**REMARKS**

**Amendments to the Drawings**

Appl'n No.: 09/777,555  
Title: Application Specific Traffic.....  
Inventors: Kevin L. Farley, et al.  
Annotated Marked-Up Drawings

Fig. 7

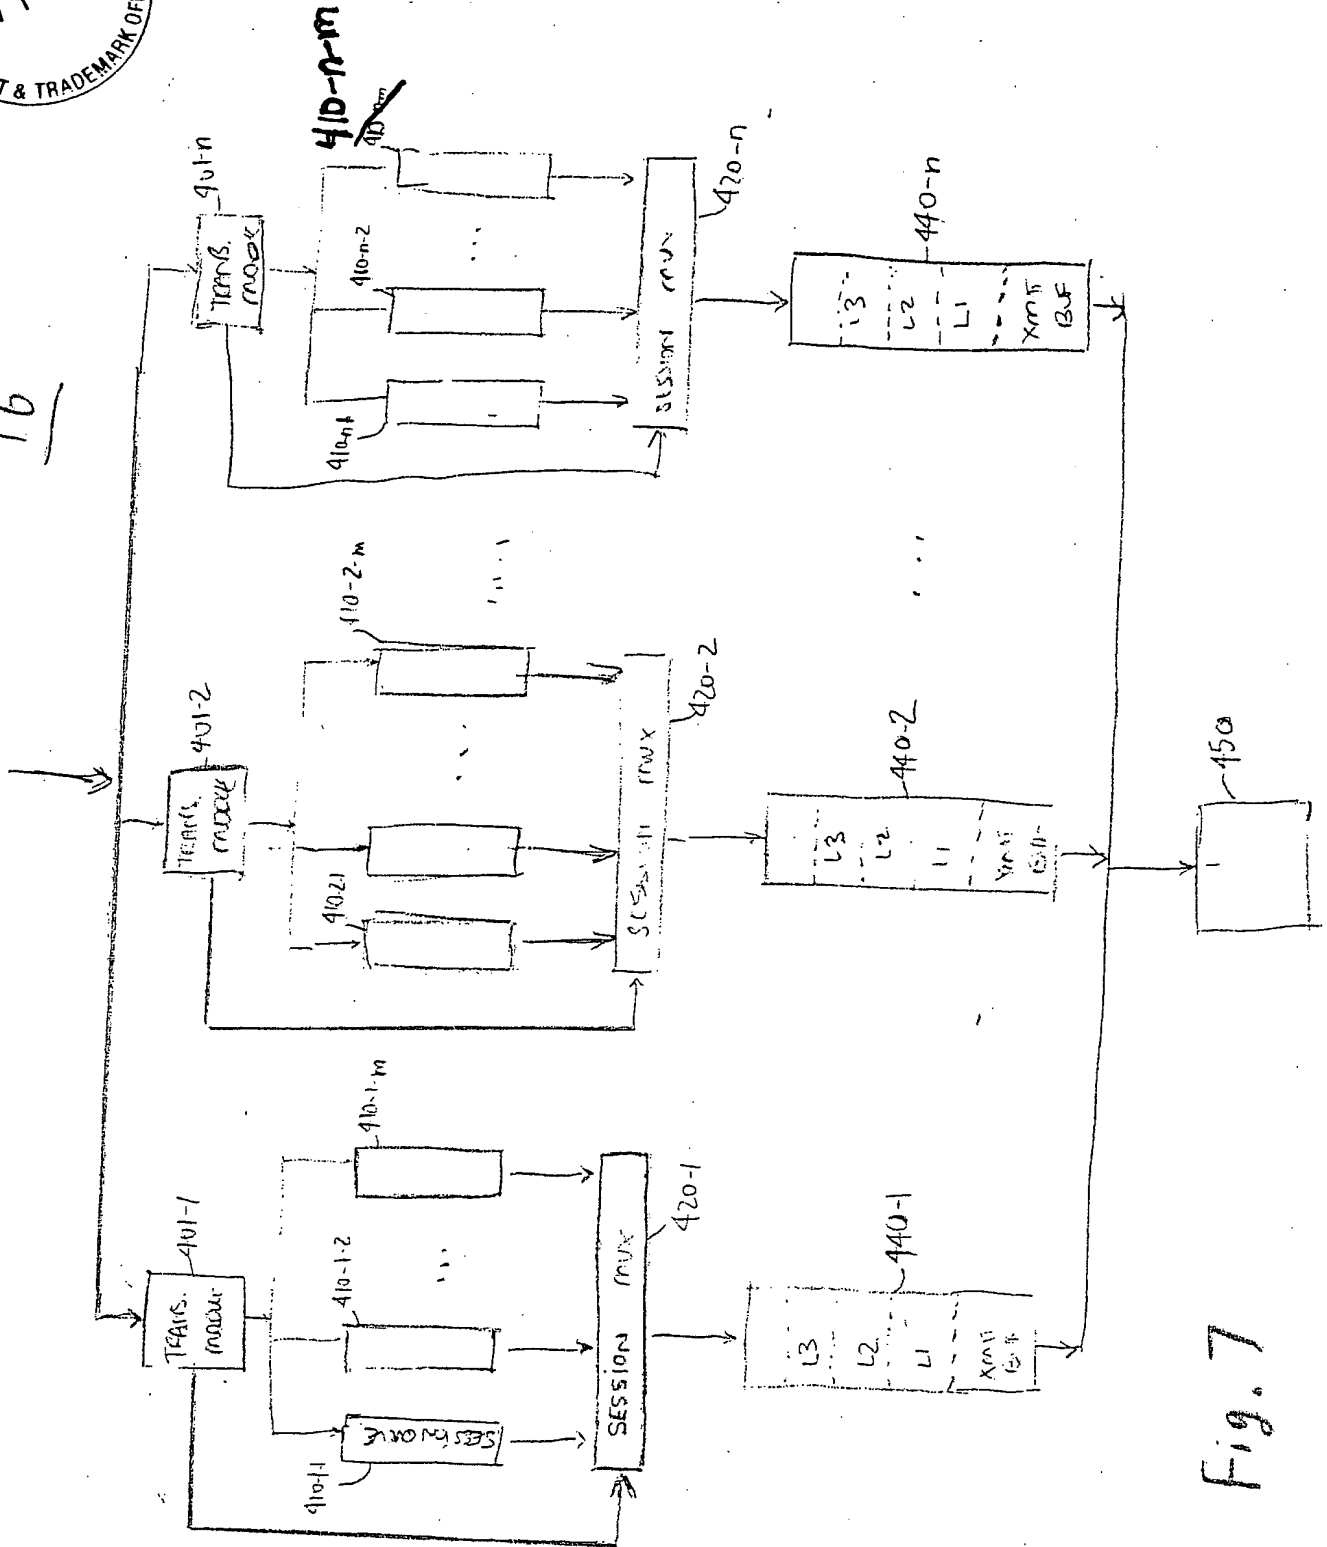
The Examiner objected to the drawings because the labels on Figures 6 and 7 were illegible. Applicants are providing replacement sheets 1-9 that include formalized drawings corresponding to all of the figures.

The Examiner objected to the drawings because reference 110 mentioned on page 9 line 19 of the specification as originally filed does not refer to radio links and does not appear in Figure 7. The specification has been amended to remove reference 110 from the specification.

Regarding reference character 410-n-m, the Applicants note that this reference character is used to identify the session queue in the far right of Figure 7. This reference character is more clearly shown in the replacement sheet 9 provided herewith.
